March 10, 2023

Project Name: PEARL JUNIOR HIGH MULTIPURPOSE
Project No: 22-056
RE: Updated Civil and Structural drawings.

ADDENDUM NO. 01

4
S304 BEARING WALL SECTION AT UPPER & LOWER ROOF - NEW ADDITION
3/4" = 1'-0"

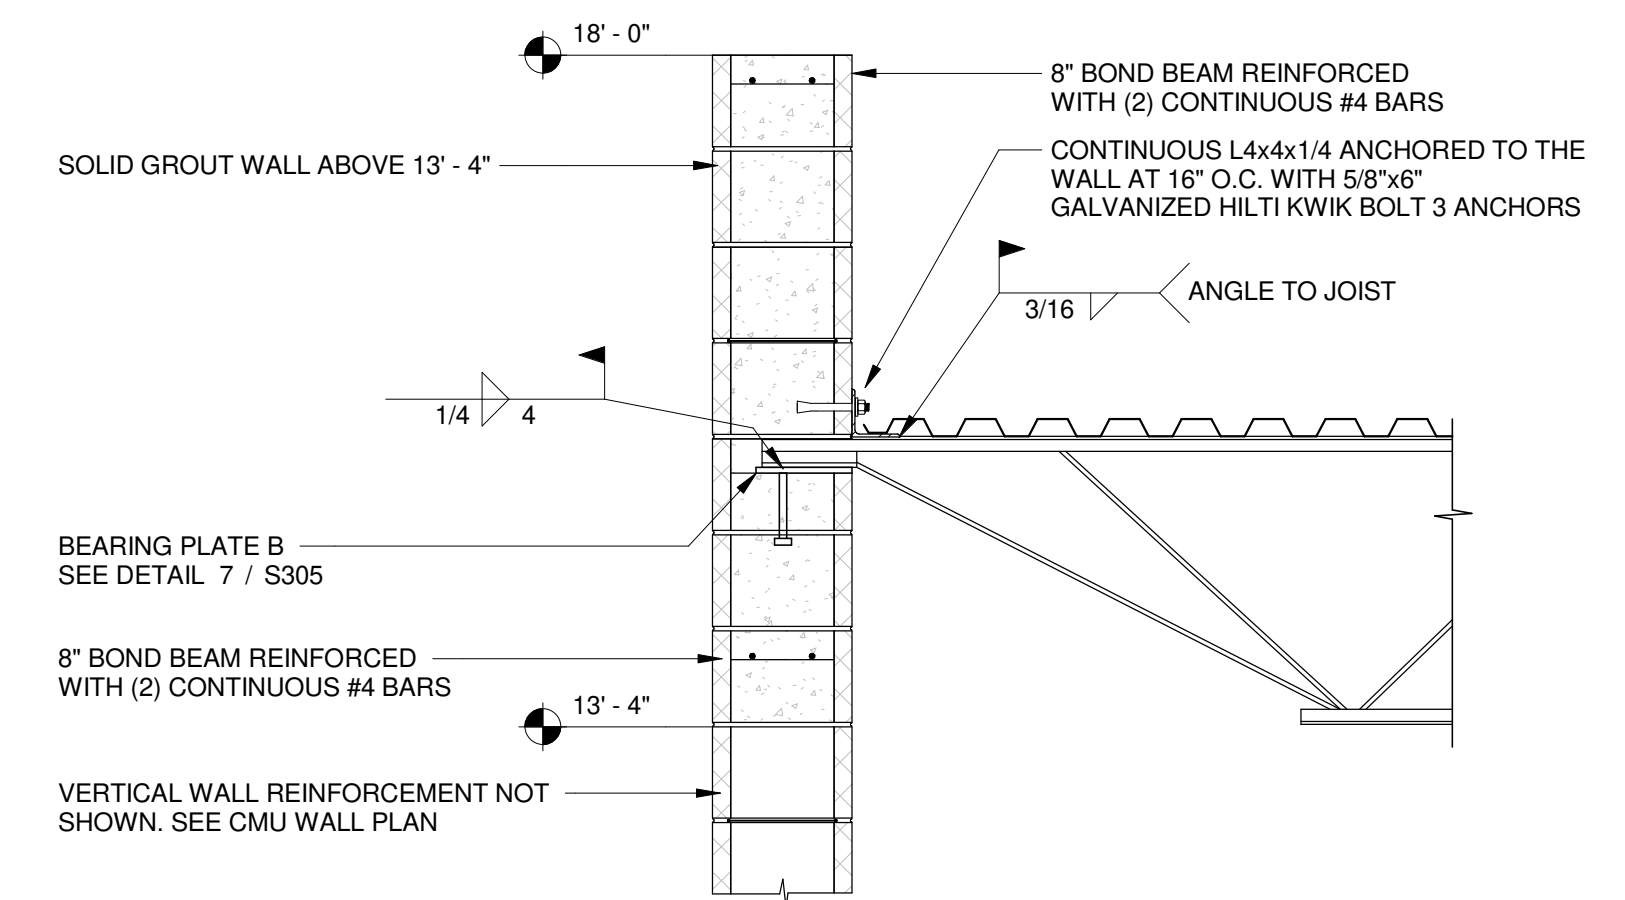
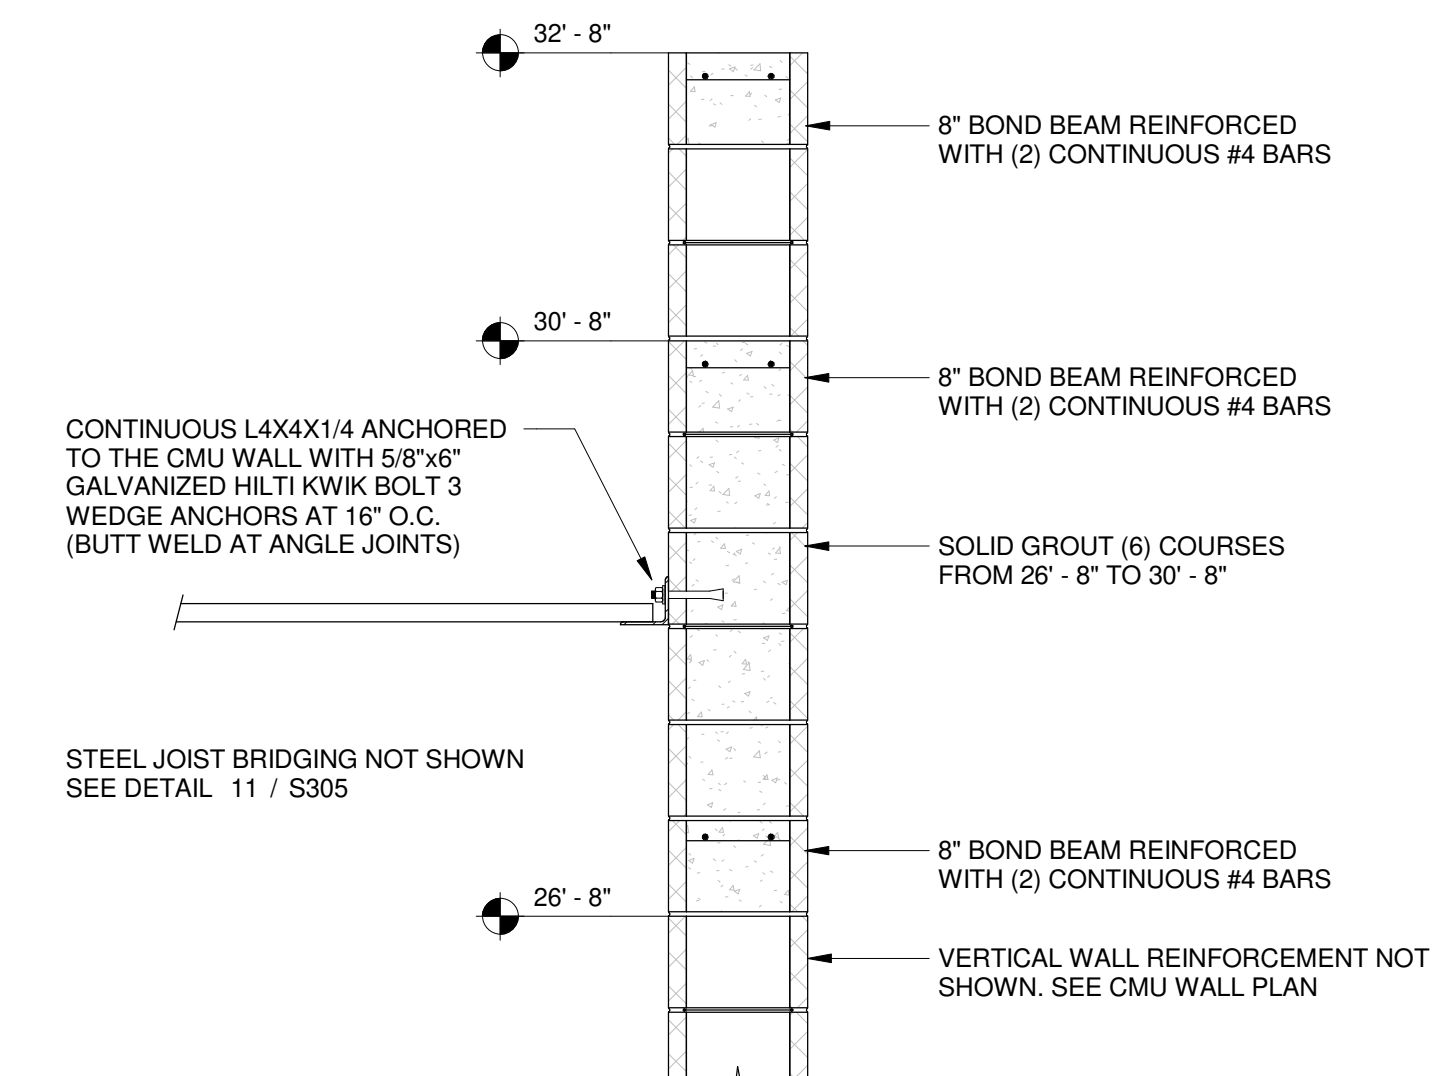
- S302 DETAILS
 - Modified top of slab level and exterior stair detail.
- S303 DETAILS
 - Added sections for mechanical screen wall.
- S304 DETAILS
 - Modified wall sections.
- S305 DETAILS
 - Modified details.
- A109 OVERALL ROOF PLAN
 - Modified the dimension of the mechanical screen.
- A402 INTERIOR DETAILS – ALTERNATE 1
 - Modified the spacing of the acoustical sealant.
